**Town of Hinesburg  
Planning Commission  
April 10, 2019  
Approved April 24, 2019**

**Revisions to Official Map and Zoning Regulations:**

Hinesburg Official Map  
Sheet 1 of 2  
DRAFT REVISIONS

**DRAFT 7**  
**Sheet 1 of 2**  
**for 3/27/19 public hearing**

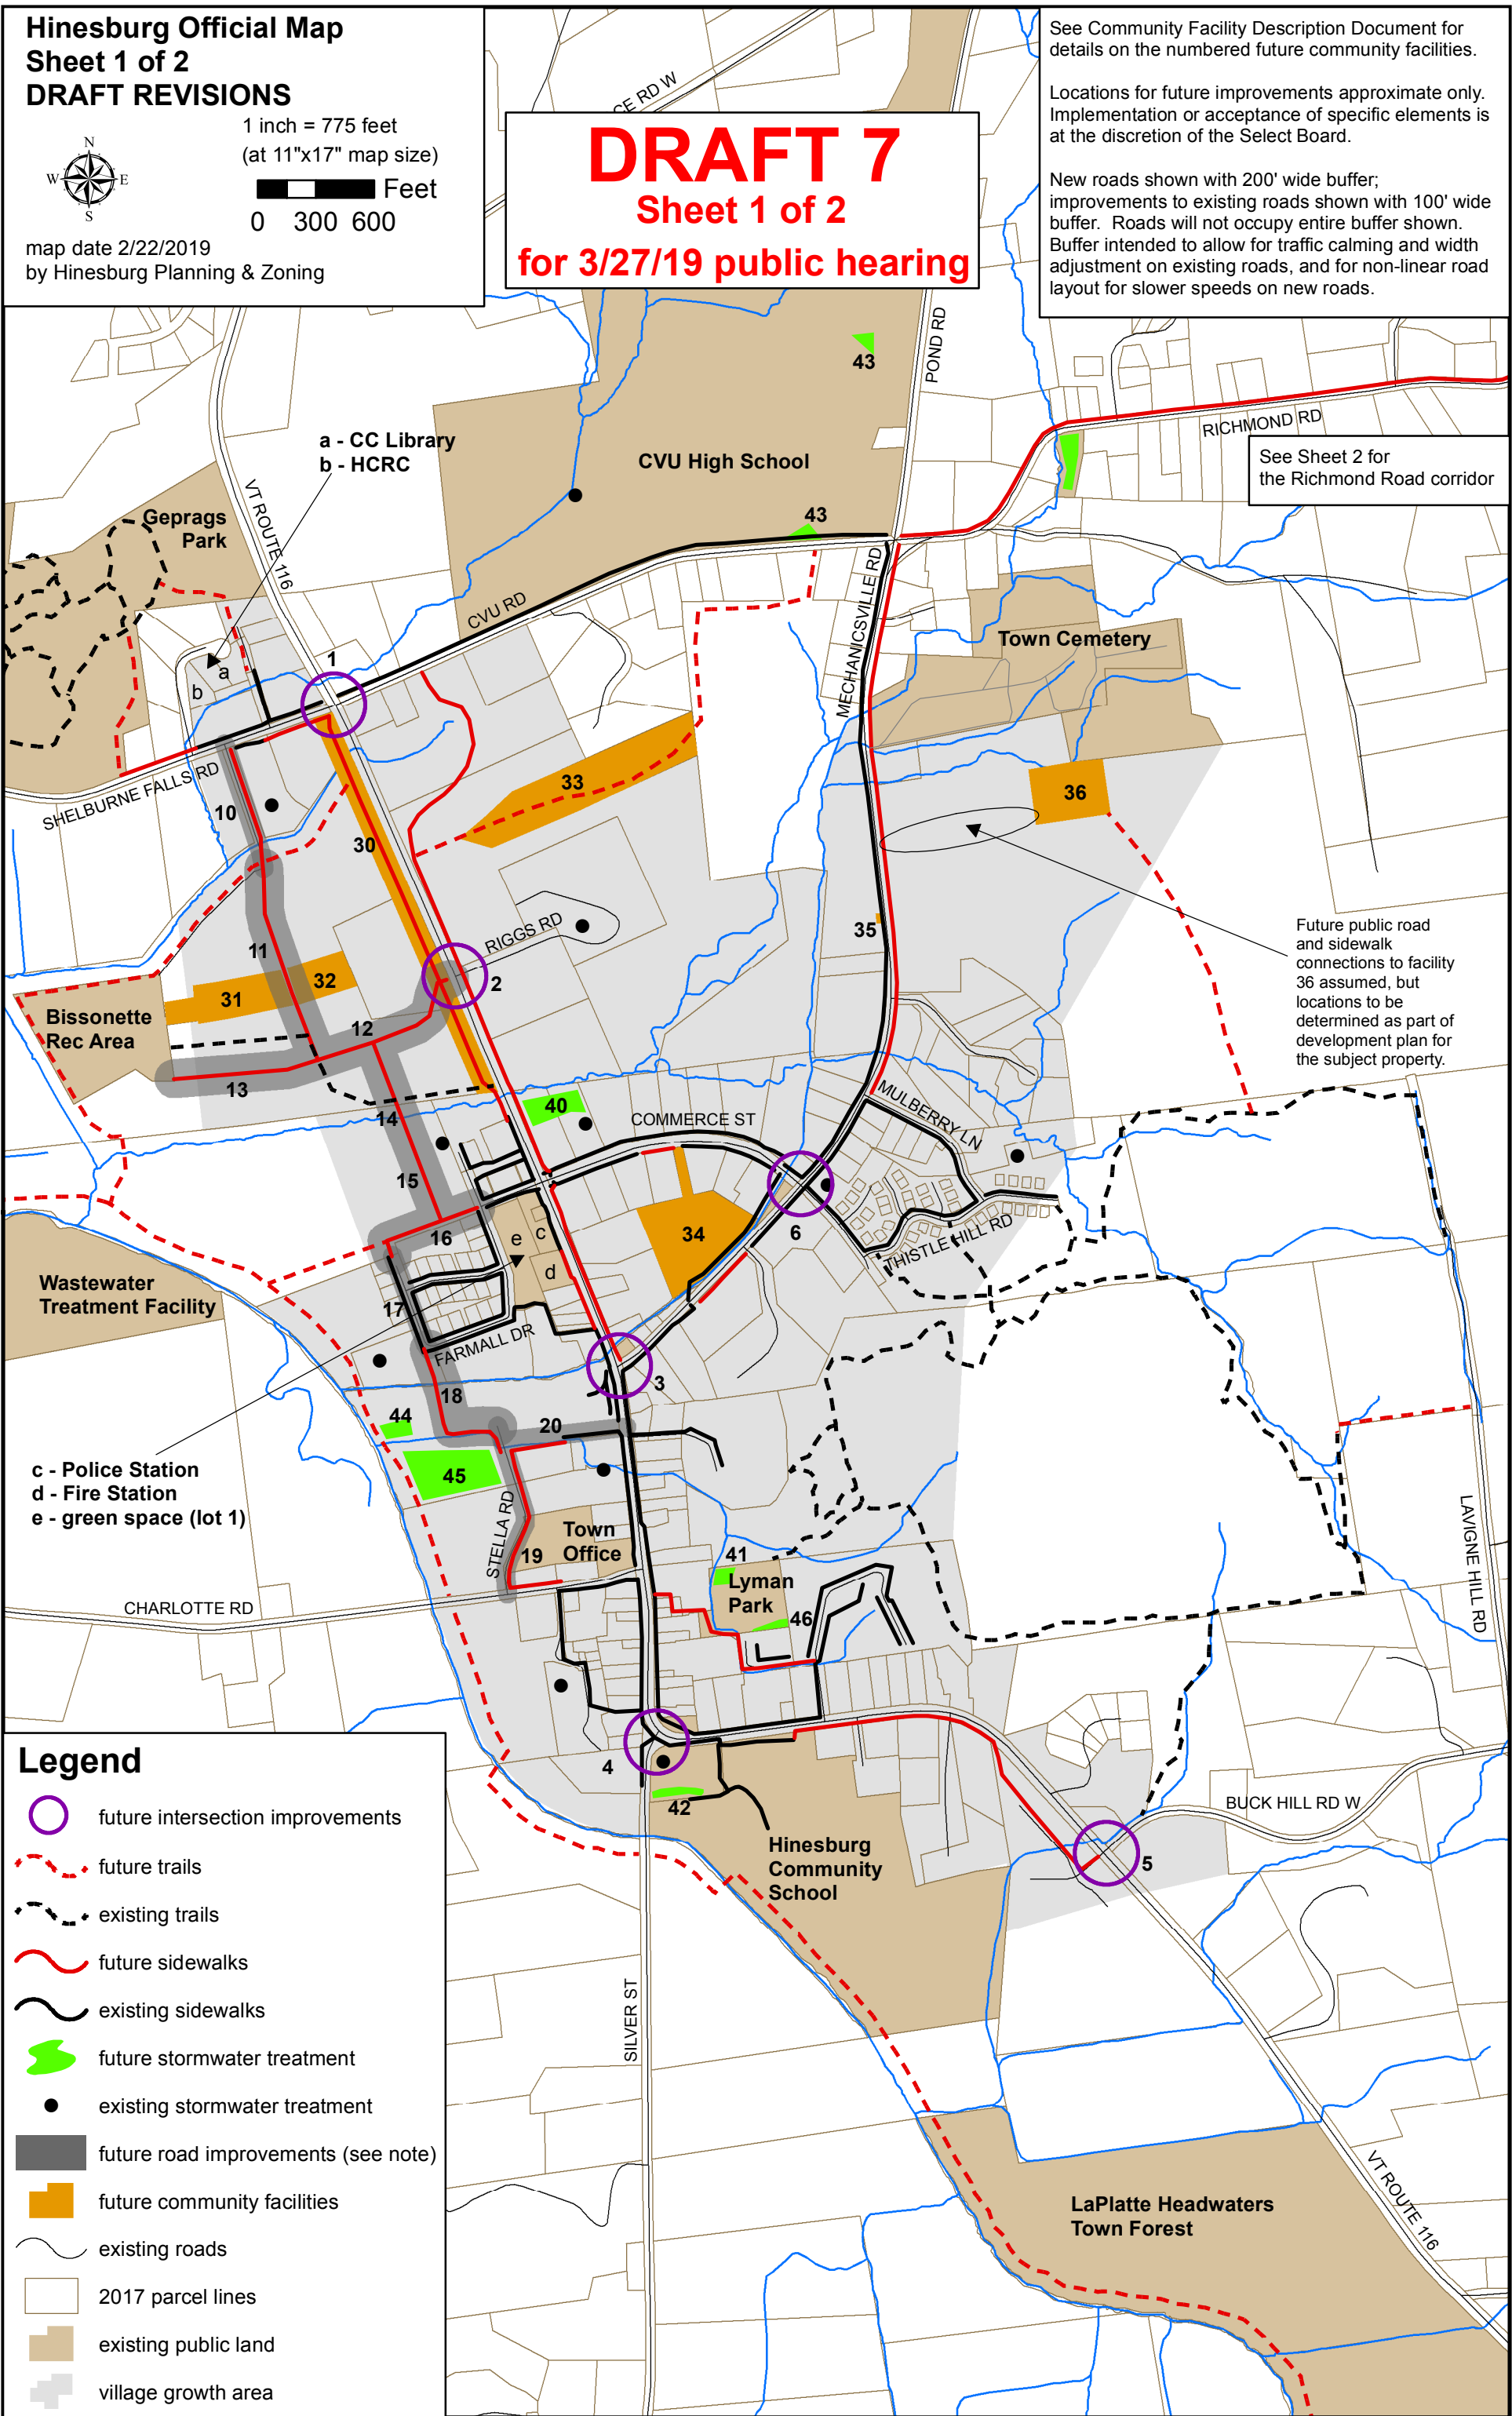
1) sidewalk east side Mechanicsville Rd.: Barbara F. remembered that it was planned for the east side originally, but feels it makes more sense on the west side, and suggested adding crosswalks at Mulberry Ln. and where cut to Quinn property is, and removing the northern part of the crosswalk. Joe I. suggested adding crosswalks at Cemetery and Hawk Ln. John K. asked about keeping the sidewalk from Mulberry Ln. north to Quinn property. James D. suggested taking the sidewalk off from the four corners down to Quinn property (leave it from the Quinn Property to the south). Alex W. thought that the design/zoning standards would require a sidewalk along the frontage anyways. If removed, it would therefore only mean that the town can't claim that area as a place for a future community facility. John K. mentioned crosswalks: Alex W. said because the town owns the road, we wouldn't have a problem putting one in. But for planning purposes, it is good to see the connections and not have gaps. Marie G. felt having sidewalks on both sides of the road is overdoing it; if we put in crosswalks and already have sidewalk on the other side, we are covered. Dennis P. asked about development on the west side of Mechanicsville; Alex W. replied there is limited potential, with more potential on the western hill (access off CVU Rd). John K. mentioned having sidewalks on both sides is crucial on Main St. Alex W. showed the regulations: in RR1, sidewalks are at the discretion of the DRB. Maggie G. suggested keeping the sidewalk on the map up to edge of Quinn property, and taking off north of there. Dennis P. asked about

sidewalk from Mulberry Ln. to Hawk Ln. (stream here); town would be on the hook for this. Rolf K. suggested leaving it from the north edge of the Quinn property, as there could be a unique path there. He would leave the sidewalk south of Hayes' property with flexibility. All agreed to leave from edge of Quinn property south to Mulberry.

Road widths: Mike Buscher's comments on numbers 11-16. Discussion ensued about widths at Farmall Dr. Joe I. mentioned you want to prescribe walkable/bikeable area (not just traffic). Marie G. said you can't make it wider after development, so it should be wide enough. Maggie G. said the wider it is, the faster the traffic, and she felt 50 ft. wide is too wide. John K. said for dead-end/cul-de-sac roads, the Commission could prescribe a particular cross-section, that's different for different types of road. Alex W. replied that the Commission would be doing this with new streetscape design standards. Alex W. clarified that the Official Map is just asking enough room for all this to happen; the Commission wanted more detail, which Alex added, but Mike B. felt this was too prescriptive. Alex W. suggested we could back off the description here (instead add language about function, with possible features instead of prescriptive details). All agreed to have Alex revise as described.

Farmall trail: Suggestion of removing a short section of trail and modifying the map to reflect current use conditions. Alex W. said the current wet conditions might change in the future given development/stormwater pond. Lenore B. suggested leaving this section, and acknowledging current sections of trail along Patrick Brook (south side). Barbara F. said a boardwalk may be solution for wet area. James D. asked about trail Mike Loner was discussing. It wrapped south of condos on Farmall Dr., went down to LaPlatte, but was never maintained by the association or town. The Commission discussed showing the section (VAST) trail; should it be on trails map and not on official map? This could be a winter-only trail. Most felt Erik Engstrom stated his case well, but didn't feel this should be added as an official map element. Maggie G. suggested we look at stream buffer map (100 foot setback on Patrick Brook); as a member of the public commented, we could feasibly add a trail next to every stream. Alex W. replied that much of the year this type of trail in the stream setback is fine, but some months you can't walk on it. John K. asked what would happen if they don't add the red line there; Alex W. replied that if the developer wanted to add a stormwater pond right there, they could, and the trail would be broken. Marie G. didn't feel the trail under discussion would change in the life of the map. Alex W. said if the developer put a stormwater pond in this area, putting it on the Official Map would require them to put a path over it. All agreed to put it on the Official Map, and to keep the original section under discussion as well (though wet now).

John K. brought up issues of a park at the intersection by Texas Hill Rd. Marie G. said the landowner who commented knew about trailer park when she purchased her home, and her home is set back a ways, and any improvement we are discussing here would not devalue her home. James D. commented this park won't be out of the way, so maybe there will be less chance of vandalism. Joe I. said crosswalks would need to go across here. This would address many town issues (sidewalk, safety of

intersection, park). Dennis P. said trailer park has space for a park on the trailer park property, and it seems unsafe to have it near the road. Alex W. noted that a future study should find landownership here. No changes made.

John K. brought up interference in back yards due to lots on top of NRG. This element (#33) sticks into where NRG's development shows houses. Alex W. clarified that this adjusted #33 has dealt with that issue. Other comments about privacy from houses along CVU Road are difficult to deal with.

There was concern about town roads around the Cheeseplant (south side 20, 18 that cut through west side of property). Landowners are concerned with road connection through property (18, that would bisect property). There was also concern also about making 20 a public road (sight lines, etc.). All felt it remains in the village's and town's best interest to keep this on the map. No change.

Hinesburg Official Map  
Sheet 2 of 2  
DRAFT REVISIONS

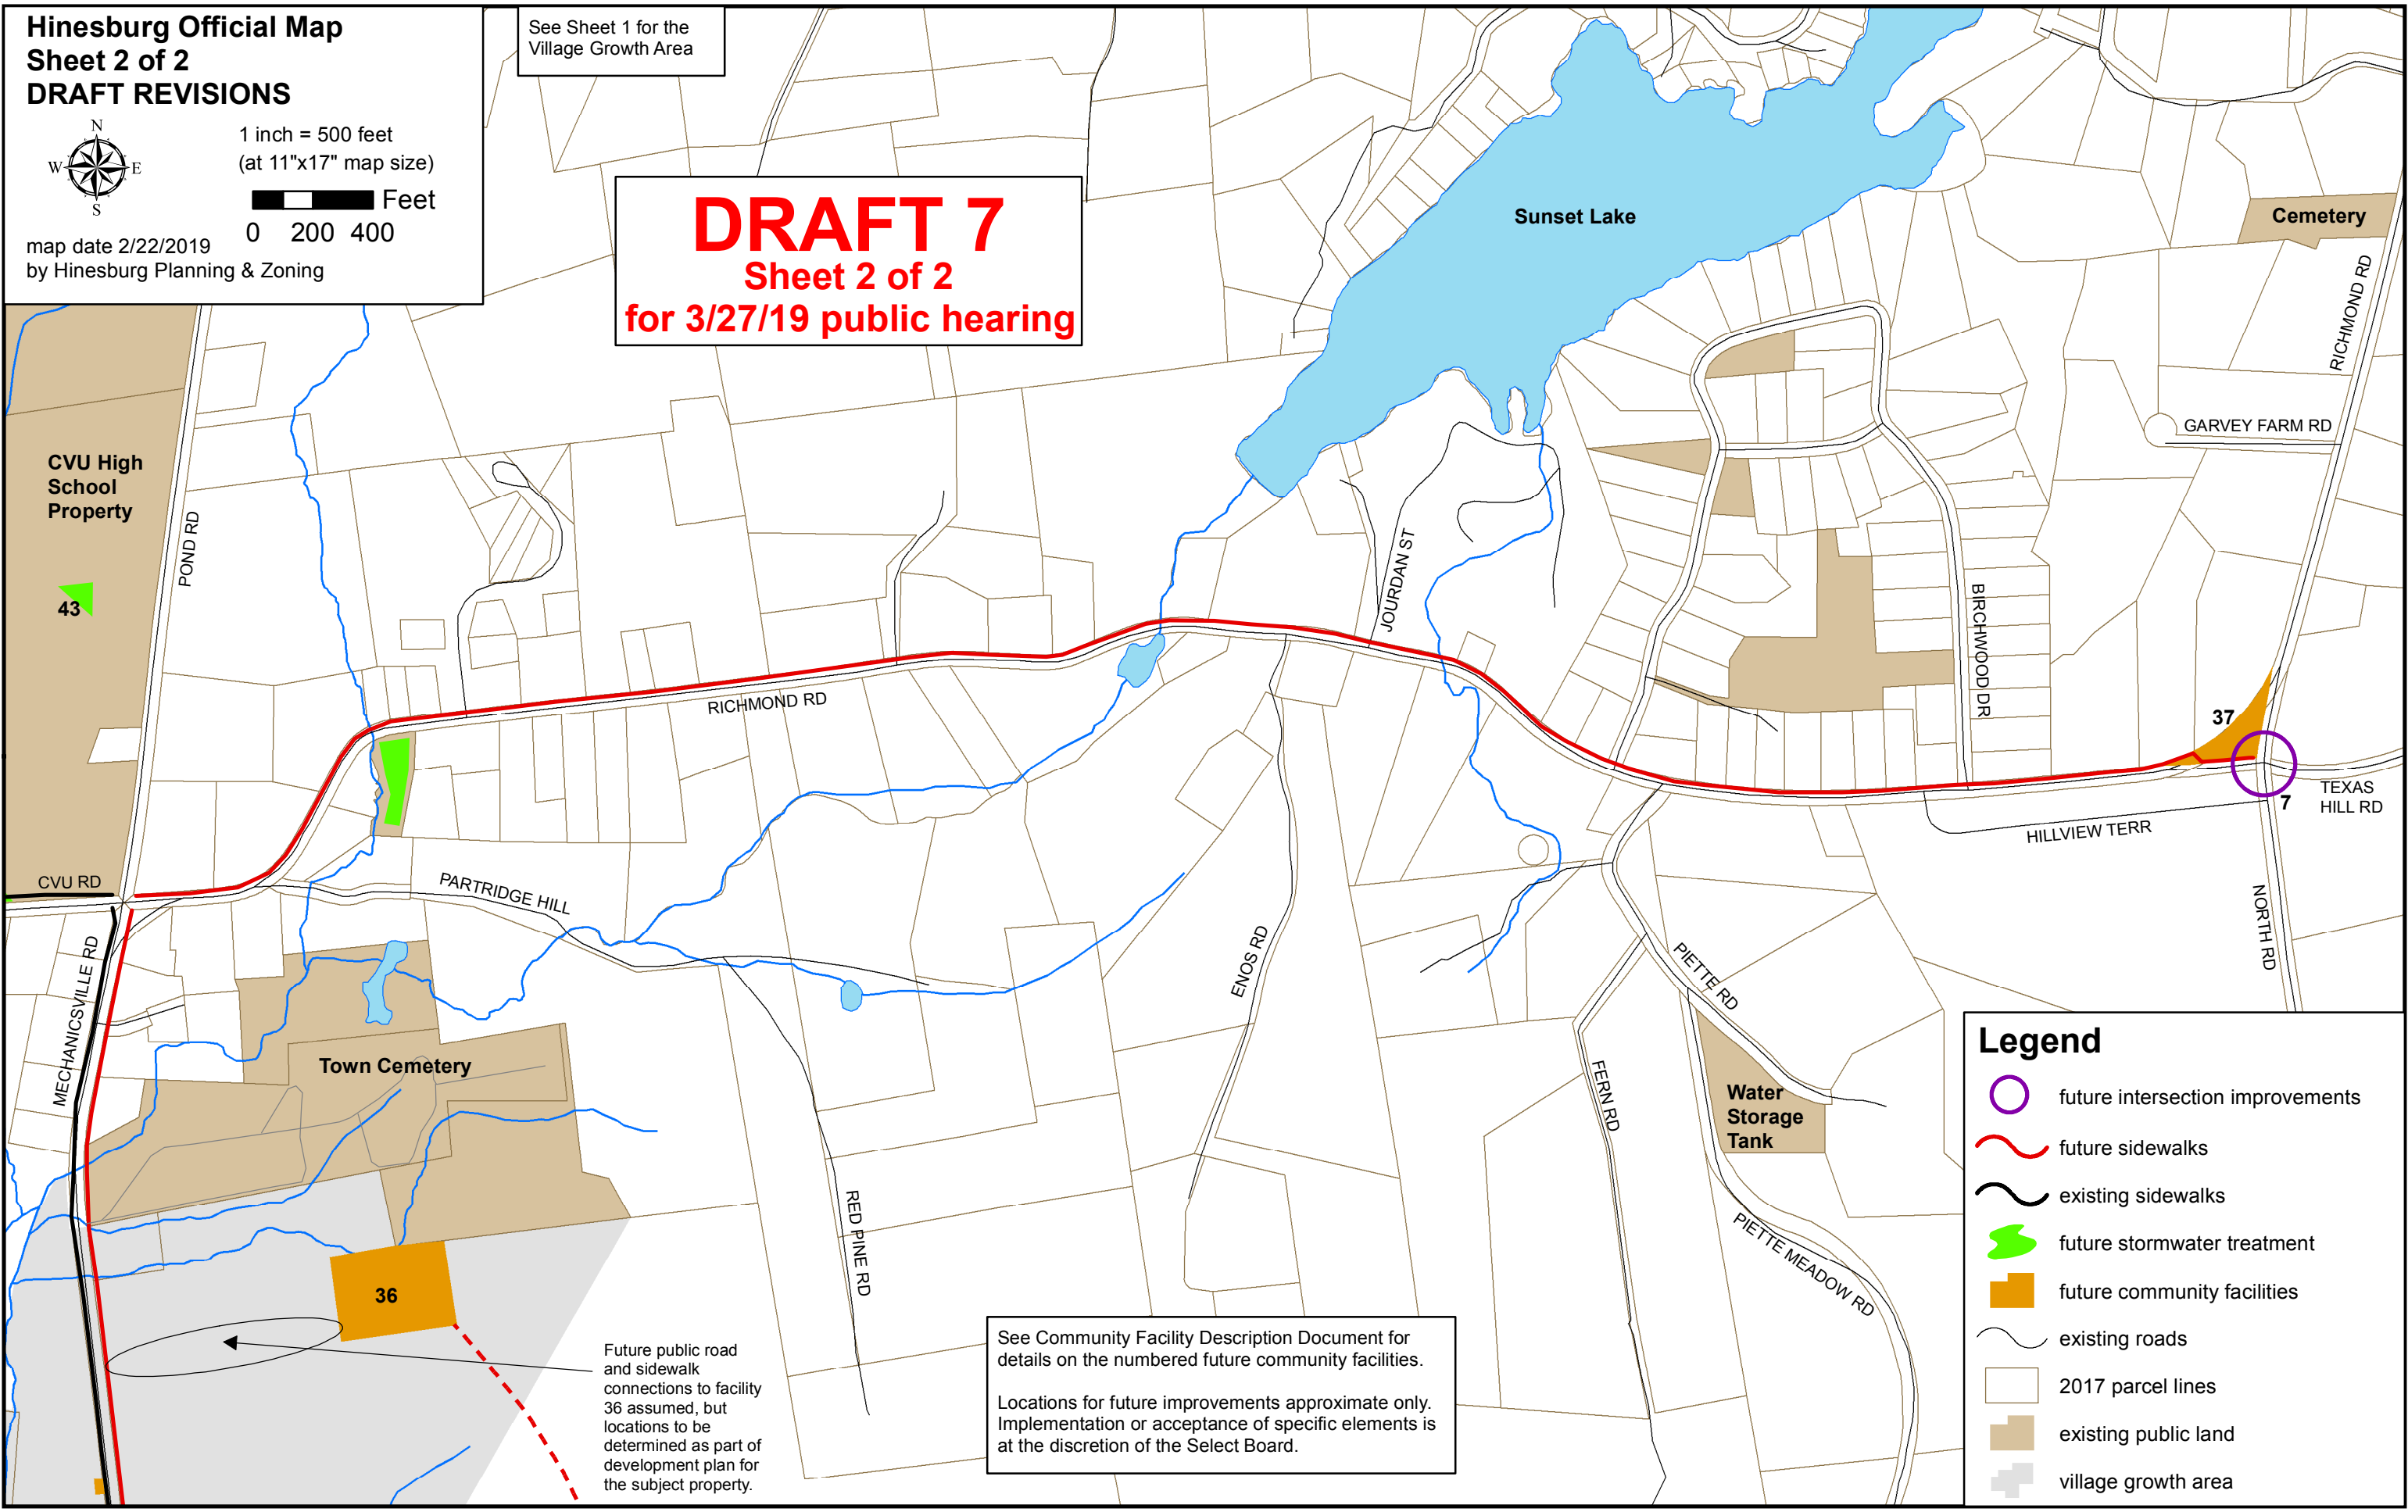
John K. brought up safety on Richmond Rd.; all agreed that is why the Richmond Rd. sidewalk is on the Official Map. The Commission has done as much as they can do in this process.
